**KyPSC Case No. 2025-00002**  
**TABLE OF CONTENTS**

**Duke Energy Kentucky  
Case No. 2025-00002  
SIERRA First Set Data Requests  
Date Received: February 14, 2025**

Exhibit 5: Current Versus Proposed Absorber Recycle Spray Pattern

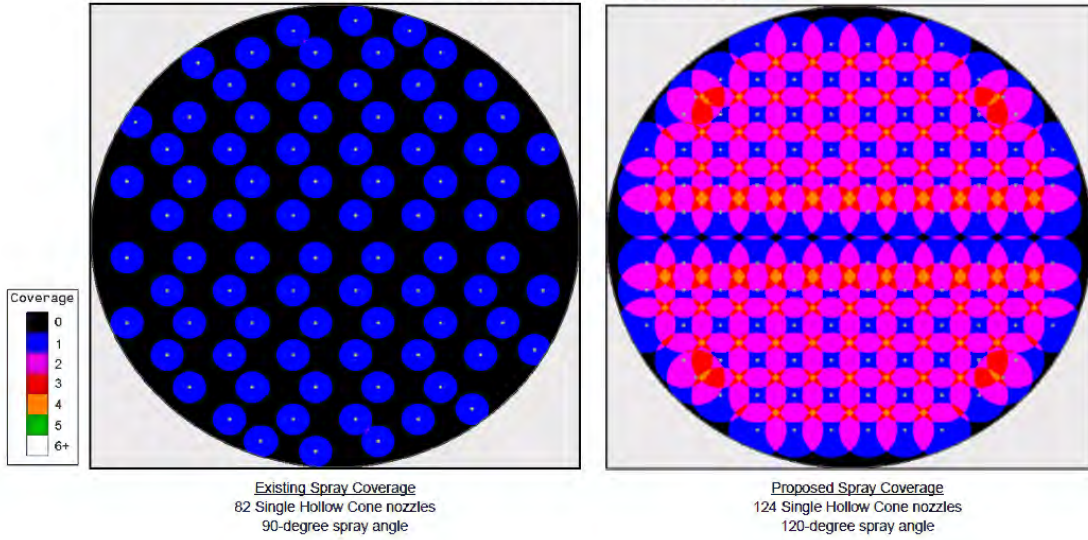
Please refer to the Direct Testimony of Witness Verderame, page 27, line 18. What “co-benefit” would accrue to assist in MATS compliance with the implementation of the Limestone Conversion Project that would not otherwise be possible with the MEL WFGD. Provide each and every such co-benefit, with supporting data.

Because limestone is a less reactive reagent, more work needs to be put into the process by means of increased liquid to gas ratio and improved spray coverage and overlap. The current maximum liquid to gas (L/G) capability of the existing WFGD is 46 gallons/1000 cu.ft. of treated flue gas and will increase to approximately 62. The number of spray nozzles will increase from 82 90-degree angle nozzles to 124 120-degree angle nozzles. The combination of these two improvements will vastly increase the spray flow and distribution within the absorber tower as seen by the diagram below. The dead zones for fine particulate to freely migrate through the absorber tower can clearly be seen on the left diagram and can be contrasted to the upgraded multiple levels of spray overlap on the diagram to the right. However, with increased absorber recirculation flow, the mist eliminator wash system intensity also has to be upgraded to prevent increased potential of mist eliminator fouling.
